MUAZUDDIN KNIT FASHION (NEW)

B-31, East Chandura, Shaipur, Kaliakoir, Gazipur
(24.033288N, 90.272368E)
16th March 2017

Observation

Beam Layout

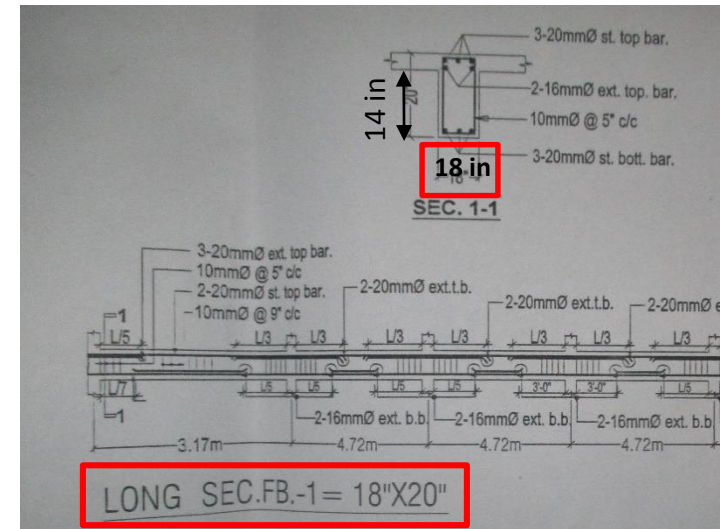
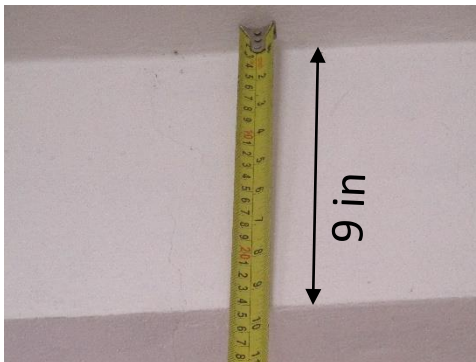
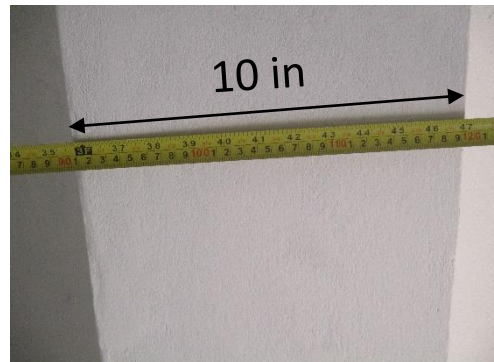
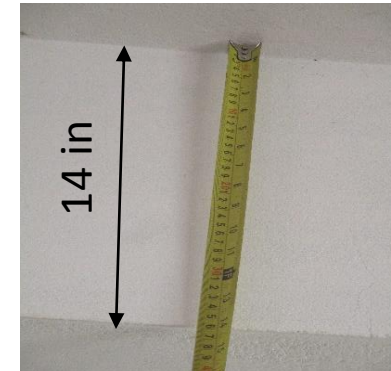
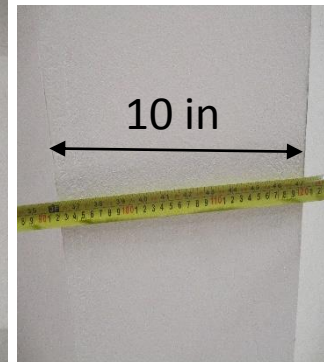
9 inch depth found under slab of long direction beam

10 inch width found of long direction beam

14 inch depth found under slab of short direction beam

10 inch width found of short direction beam

Depth of beam found from under slab was 9inch instead of 14inch and width was found 10 inch instead of 18 inch for long direction beam. However, no information was found regarding the short direction beams in provided drawing.

Column Layout

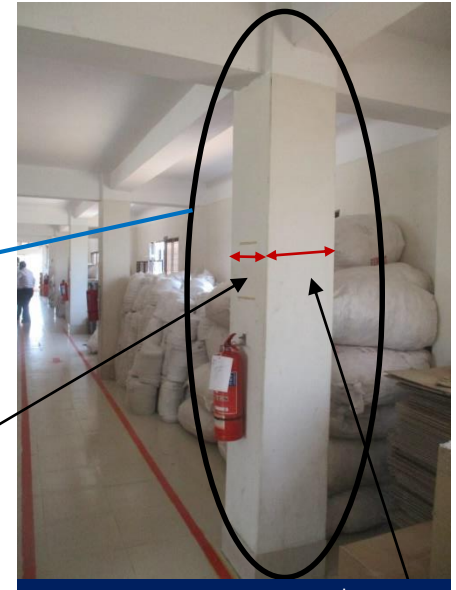
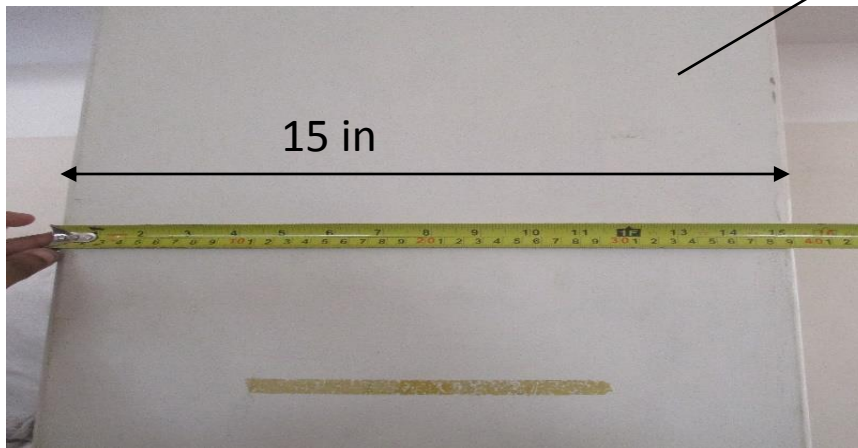
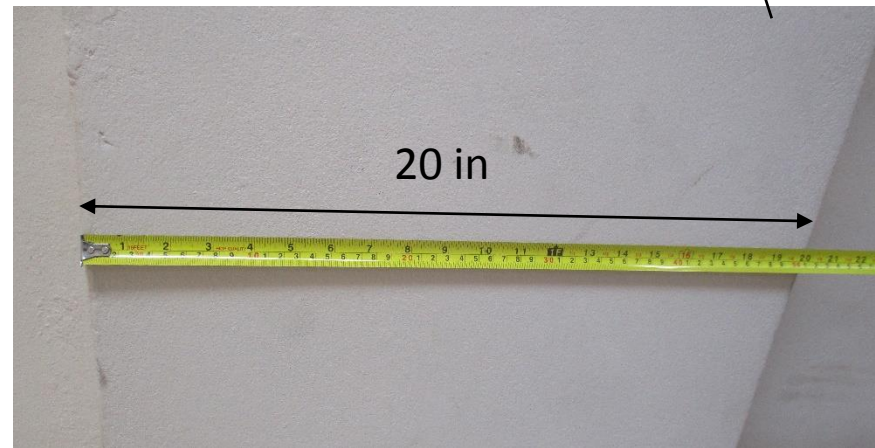
C-1 column type on 3rd floor

Column dimension was found 15 inch with plaster on short direction

Column dimension was found 20 inch with plaster on long direction

C-1 type column dimension was found 15inch x 20inch with plaster instead of 18inch x 20inch which was in provided drawing.

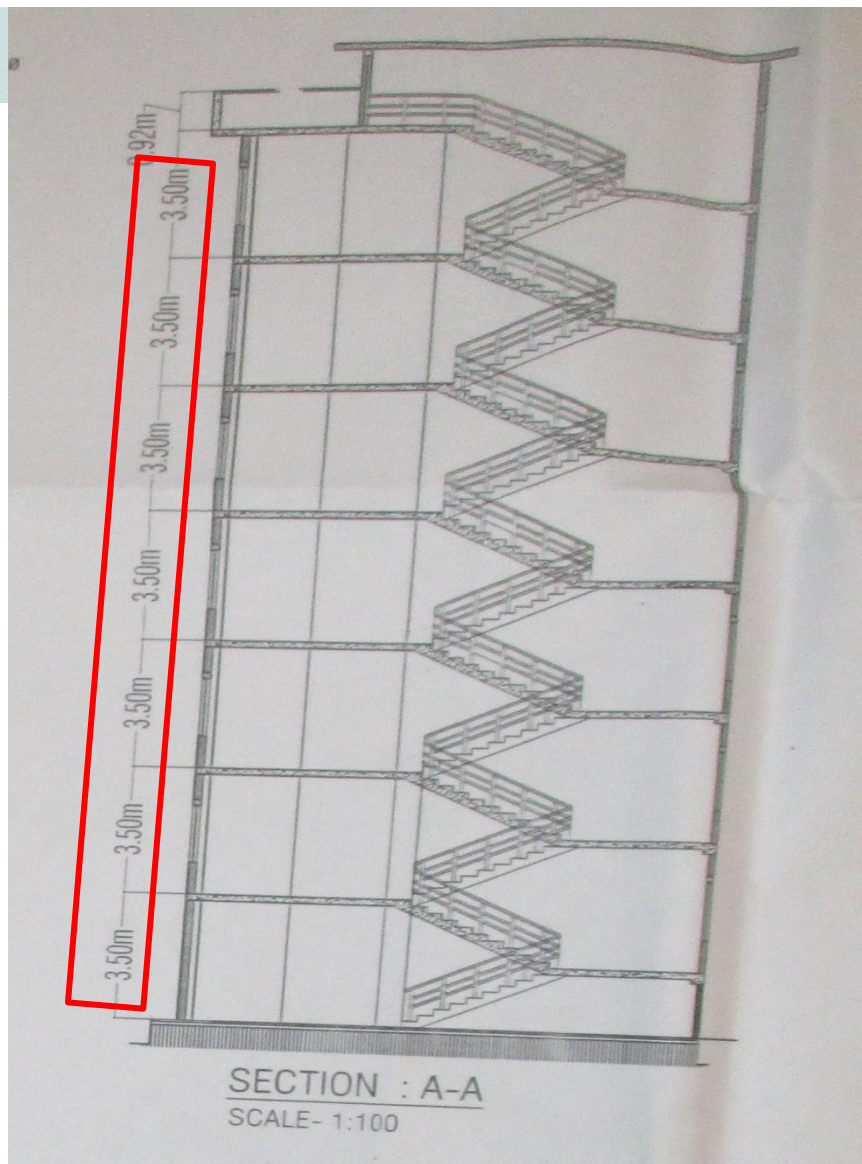
Floor to ceiling height was found 2.8m for typical floor and 4.5m for ground floor whereas in provided drawing, all floor height was mention as 3.5m.
